First Technology Safety Systems

Minor updates and
pusher plate discussion
for Flex Pli GTR

1 December 2009

Catch rope idea

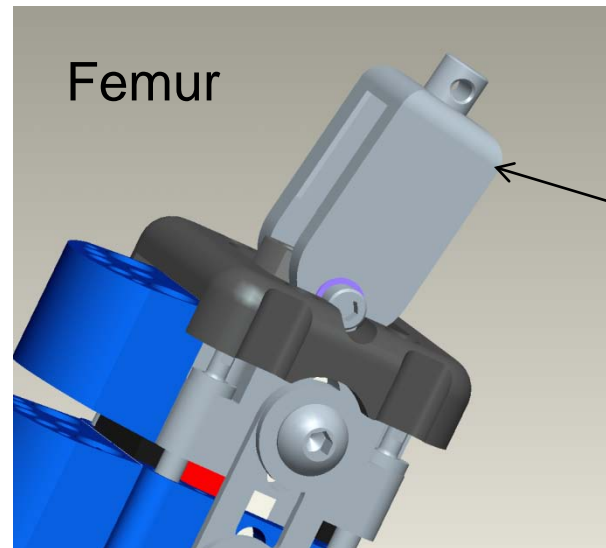
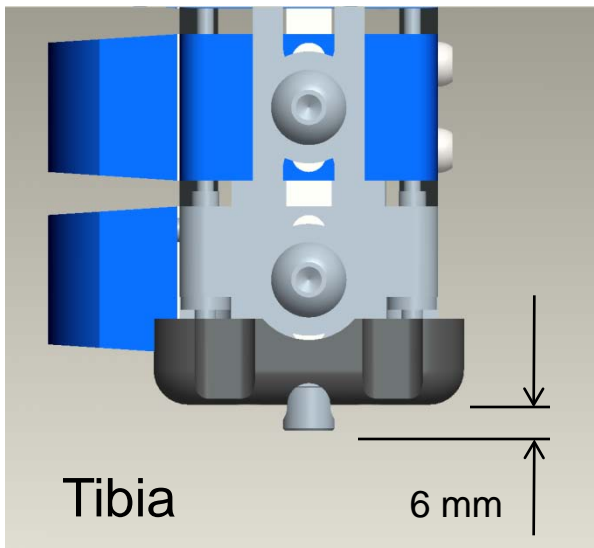
M8 pin, aluminum or steel with 5 mm hole for steel wire loop

Guide has been thickened at top from 6 to 8 mm

Impact segment improved positioning

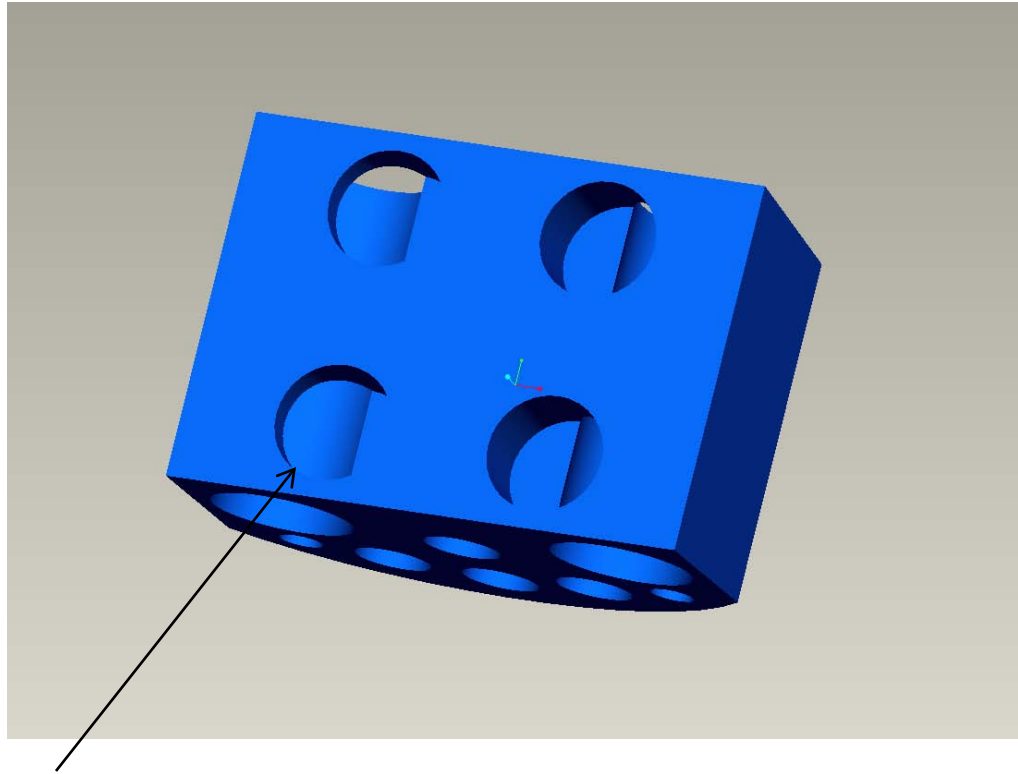
Reduce hole size on impact segment from 10.7 to 10.5 mm diameter for more accurate location. Screw head size varies from 10.15 to 10.35 so no problem with fit tolerance

Spacer tubes to prevent plastic compression

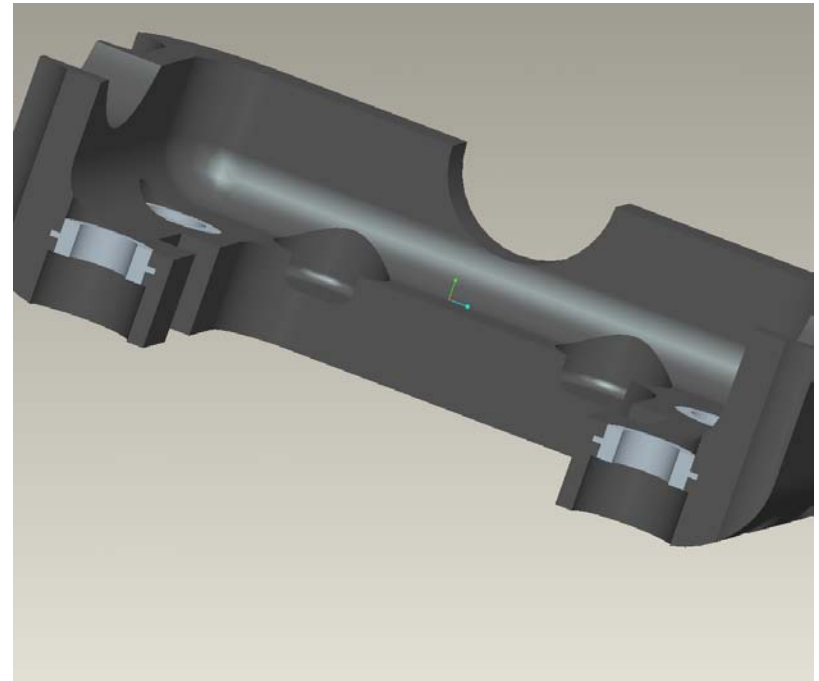
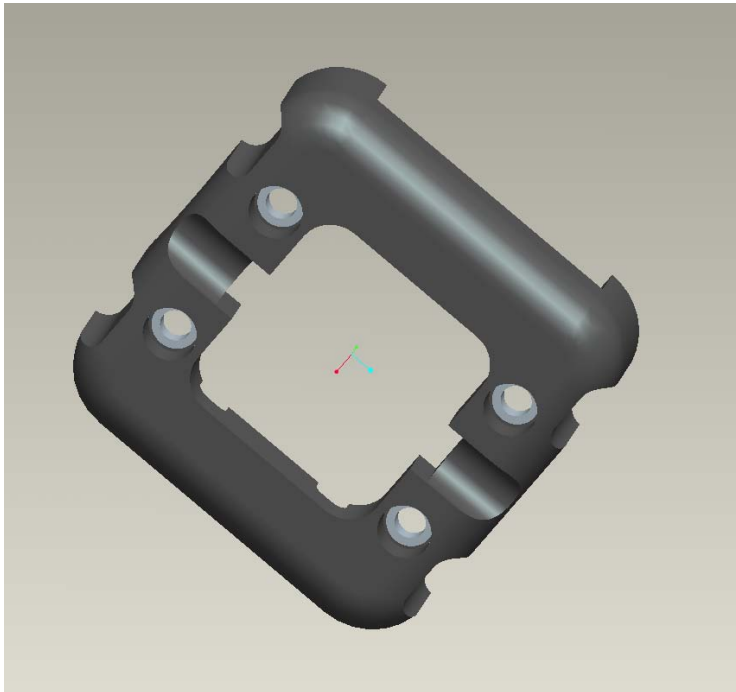
Aluminum spacer tubes molded into protective cover

Bonding bone buffer

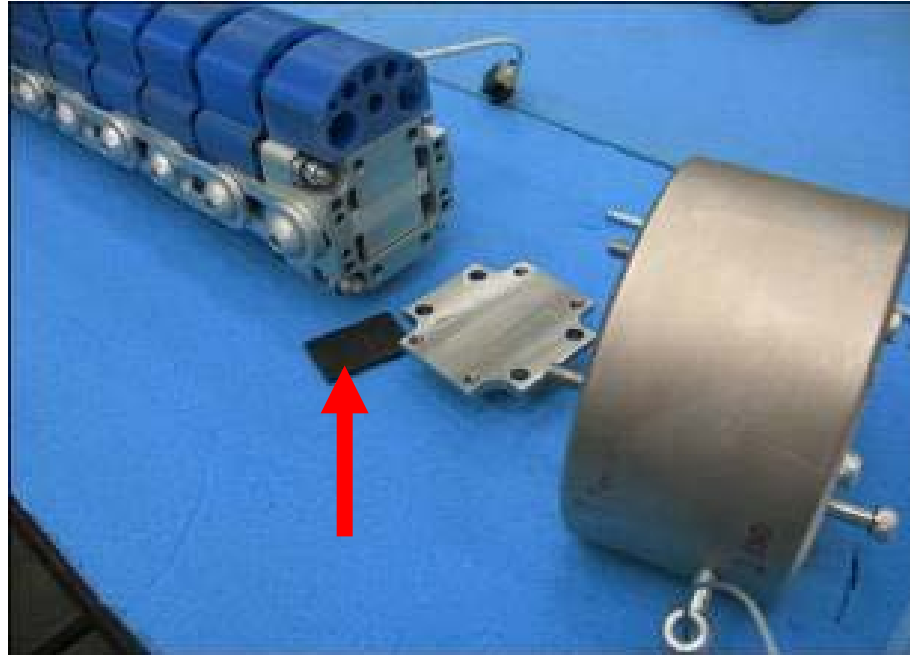
Bond end bone buffer both ends for correct location
and to ensure part is in place after disassembly
bond will not be too strong

New ballast weight attachment for pendulum rig

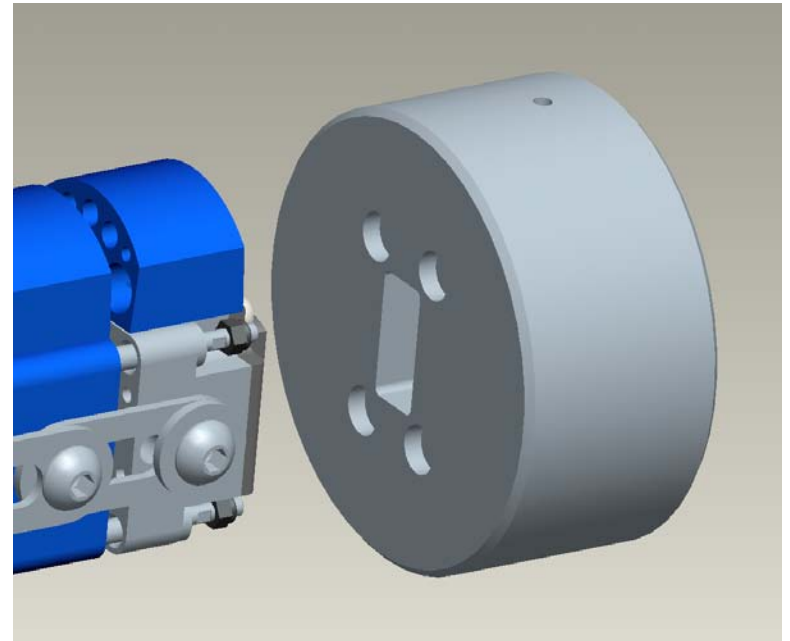
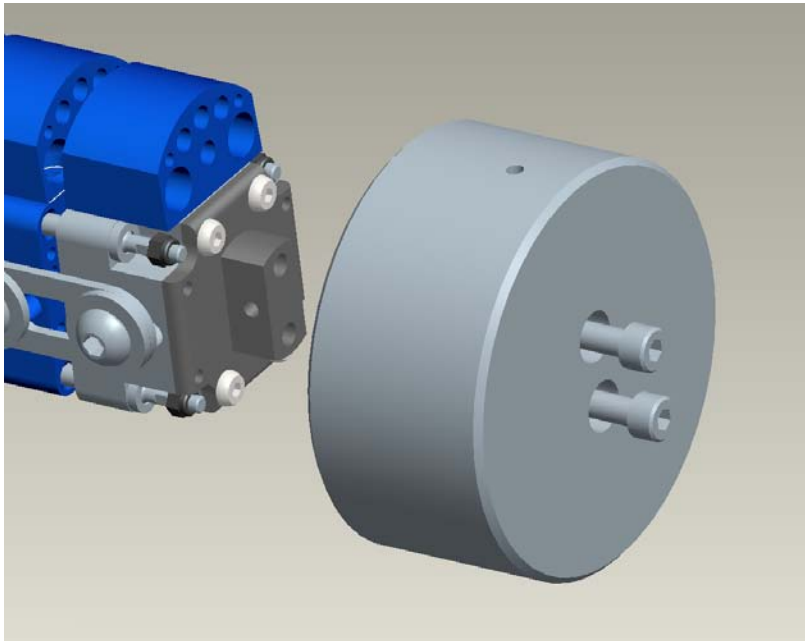
New proposal avoids need to remove femur top plate
and is easier to locate and fit

Setting tools

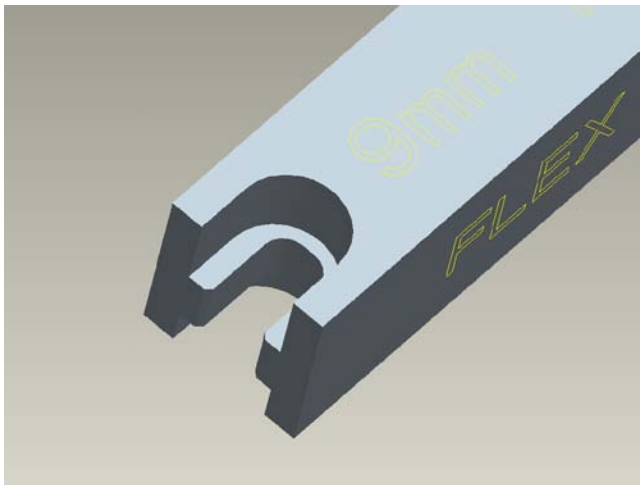
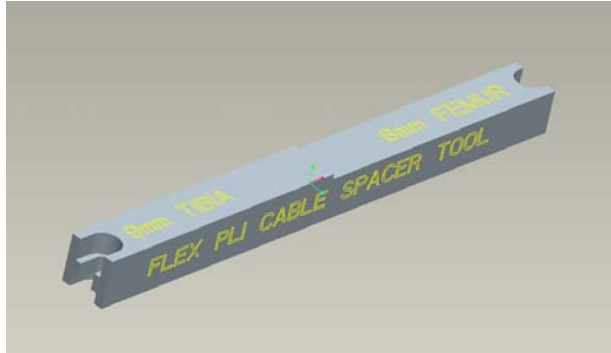
Incorporate flat in setting tool
to replace use of 2 wrenches, making
adjustment easier

2x string pot attachment
setting block for knee assembly
now supplied in toolbox

Front view of
JARI pusher plate

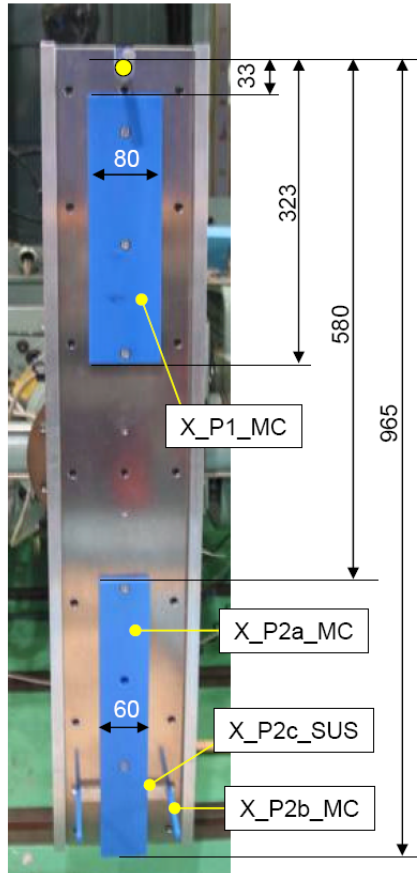
For high acceleration push phase
JARI recommends 6 mm plate
behind knee area

Do other users agree to these dimensions?
